City of Brisbane

Planning Commission Agenda Report

TO: Planning Commission For the Meeting of June 23, 2011
FROM: Tim Tune, Senior Planner, via John Swiecki, Community Development Director
SUBJECT: **3000-3500 Marina Boulevard;** Design Permit DP-2-11, Use Permit UP-7-11 and Variance V-2-11; Time Extensions for Design Permit DP-5-07 Approving Two Office Buildings and a Parking Structure with Related Site Grading, Use Permit UP-3-08 Accepting 1,373 Parking Spaces Including 1,175 "Universal" Spaces Located Off Site within the Parking Structure, and Variance V-1-08 for the Parking Structure's Lot Coverage and East Side Setback; Don Little, Don Little Group, applicant; Sierra Point LLC, owner; APN 007-165-020

Site Circulation Plan, Keyed to the Schematic Landscape Plan Enlargements and 1st Floor
Office Floor Plans

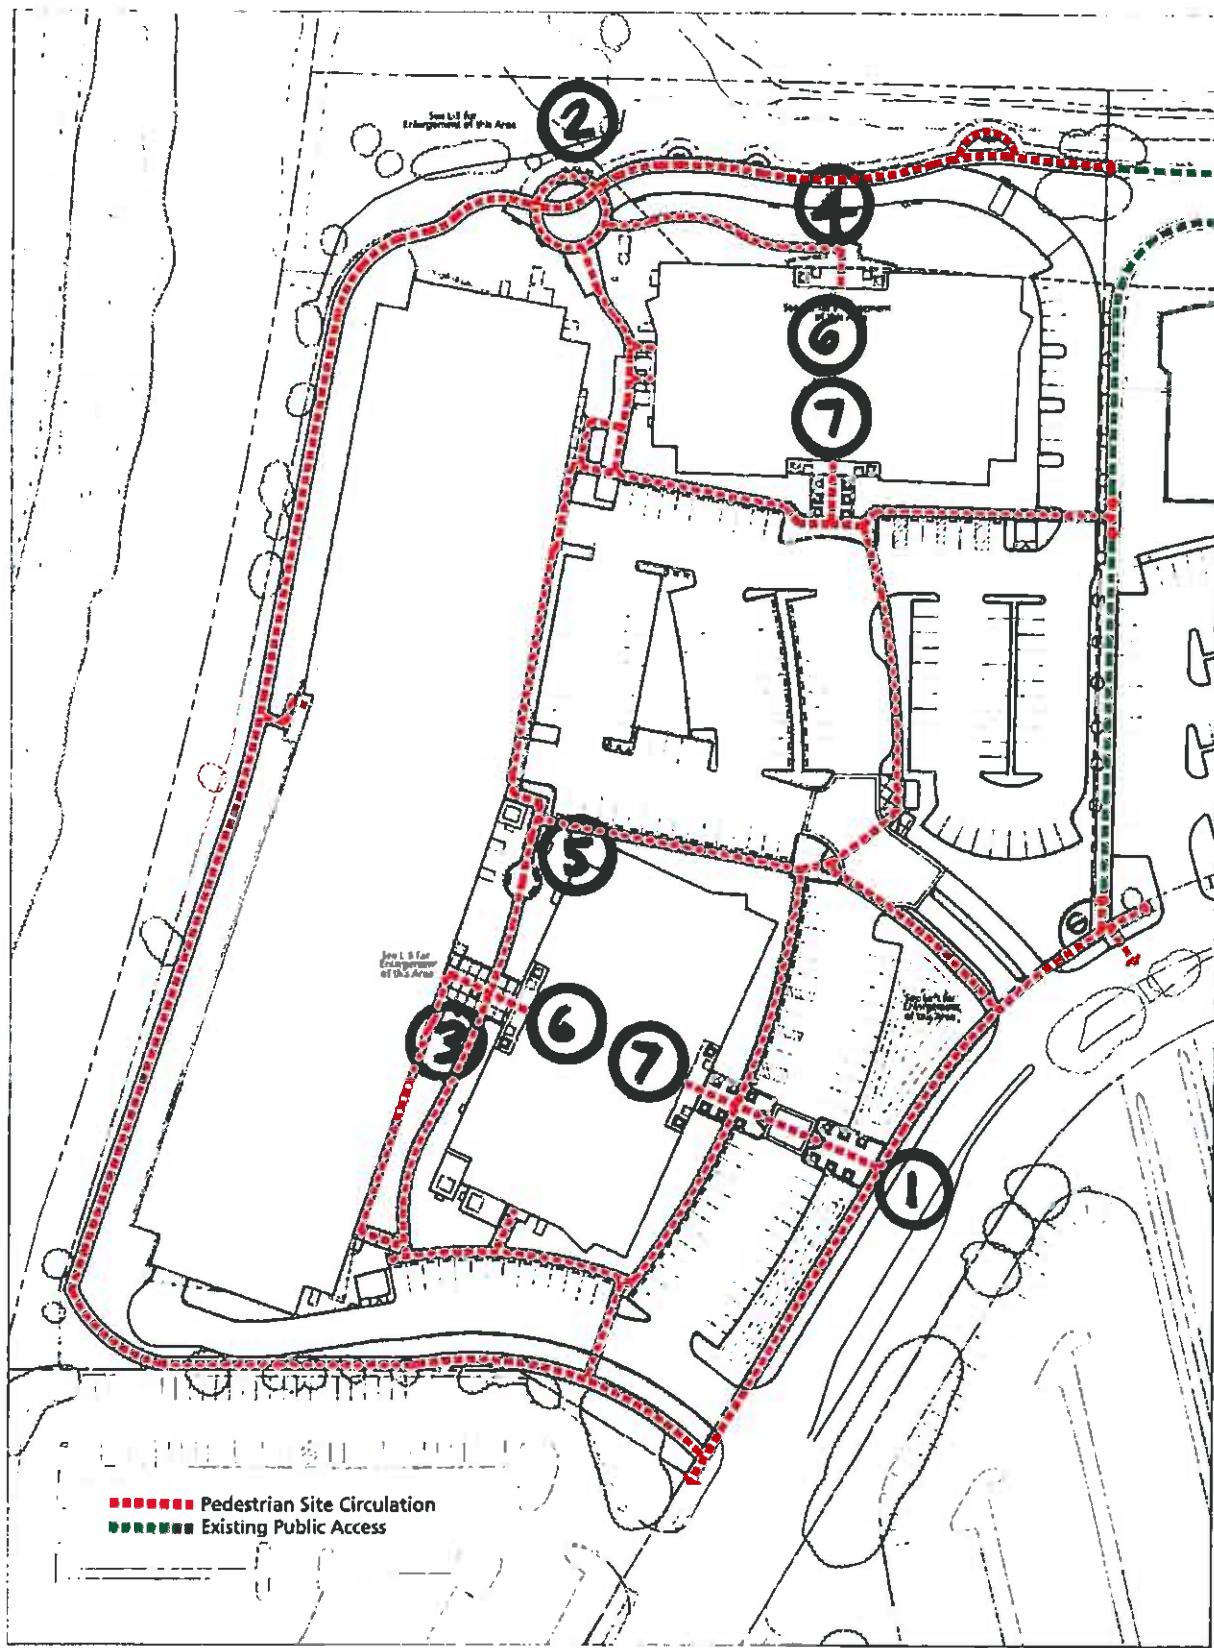
Public Space—To clarify where public spaces are proposed for the project, staff has attached an annotated version of the Site Circulation Plan, keyed to the Schematic Landscape Plan Enlargements and 1st Floor Office Floor Plans (each building will contain 2 entry lobbies, each with approximately 800 sq. ft. of indoor public space). Tables, chairs and benches are proposed to be provided on the east and north sides of the garage, which would provide some shelter from the winds that come around the southern slope of San Bruno Mountain, as well as on the north side of the 8-story office building. The street furniture and employee gathering area details will be incorporated into the landscape plans submitted with the Building Permit application per Condition G.11.e. The wind sheltering ability of the trellis/canopy elements required at all building entrances will be subject to the Community Development Director's review per Condition G.3. Note that the LEED core & shell rating system does not specifically award points for outdoor public spaces, except in terms of protecting indoor environmental quality by restricting smoking to designated outdoor areas away from building openings.

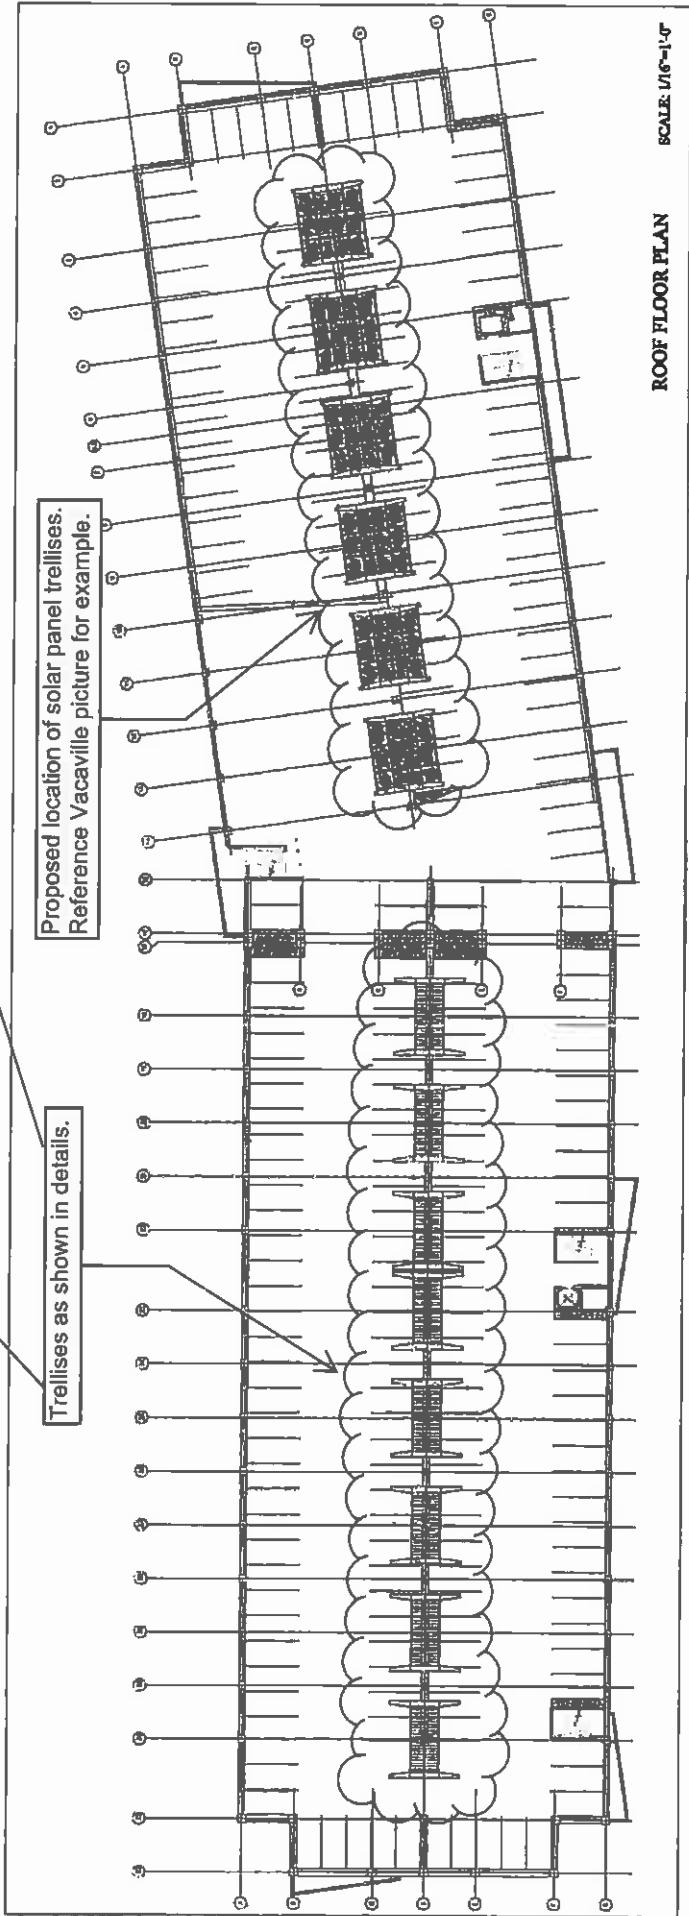
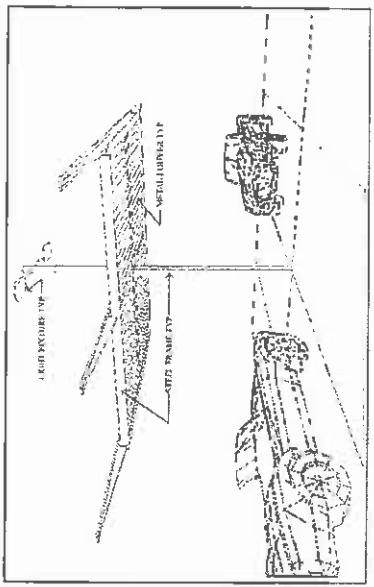
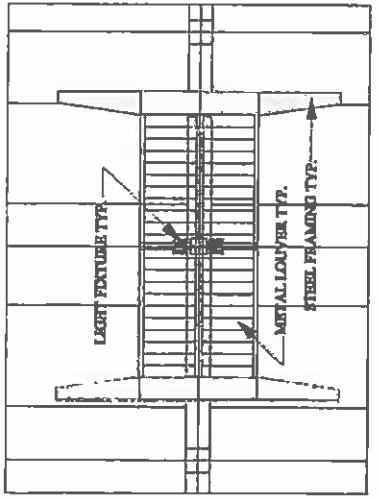
Cost: \$360,000 / \$8,000 KW-ac = 45 KW-ac Solar System

Size: 45 KW-ac * 100 SF/KW-ac = 4,500 SF of Solar Panel

Power: 45 KW-ac * 1,400 KWh/year = 63,000 KWh/year Generated

Analysis: Spending \$360,000 on renewable energy will afford for solar panels on approximately 6 trellises measuring 25' x 30' (4,500 total SF). The power produced by these panels will generate enough electricity to offset 1.5% of the total project electrical demand or enough power to offset 10% of the total parking garage electrical demand.

[Option 1] Garage Plans

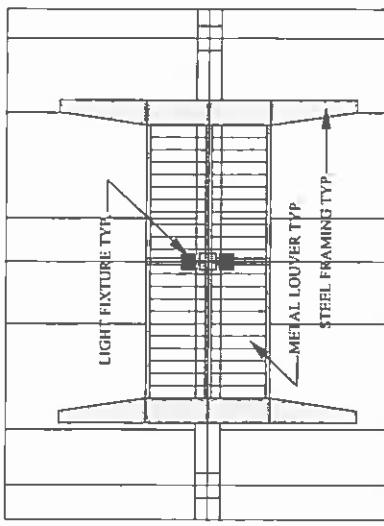
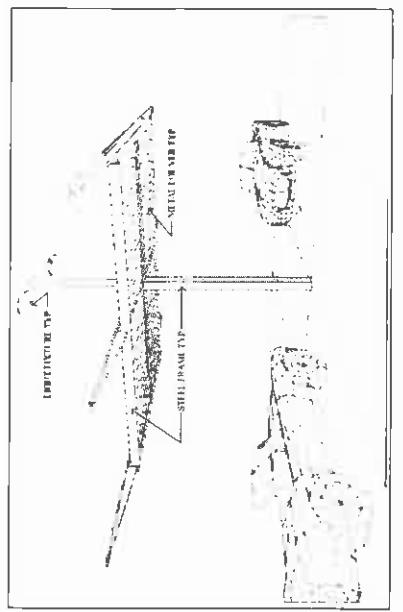
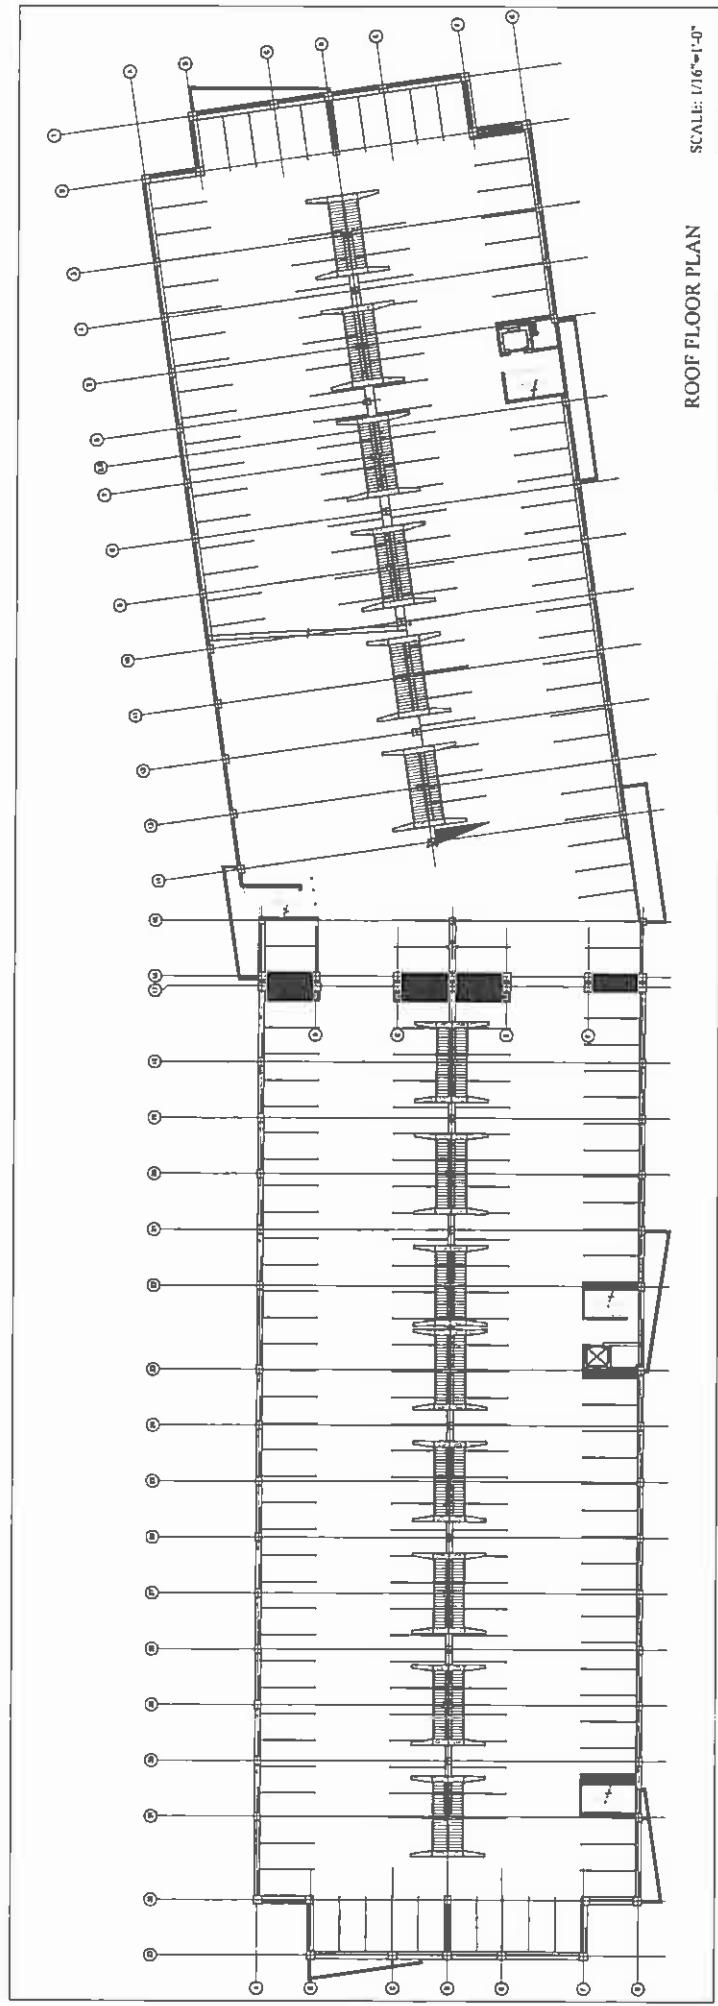
Renewable Energy—Condition V as amended by the City Council provides the applicant three options:

- 1.) install 4,500 square feet of photovoltaic panels on the north half of the garage roof and decorative trellises on the south half of the garage roof; or
- 2.) install wind power equipment having the capacity of generating electrical power at least equivalent to the solar panels described in Option 1, subject to approval as to the capacity, design and location of such equipment by the Planning Commission; or
- 3.) install decorative trellises on both the north and south halves of the garage roof and make a cash contribution in the amount of \$360,000 to the City of Brisbane to fund off-site renewable energy projects, as determined by the City.
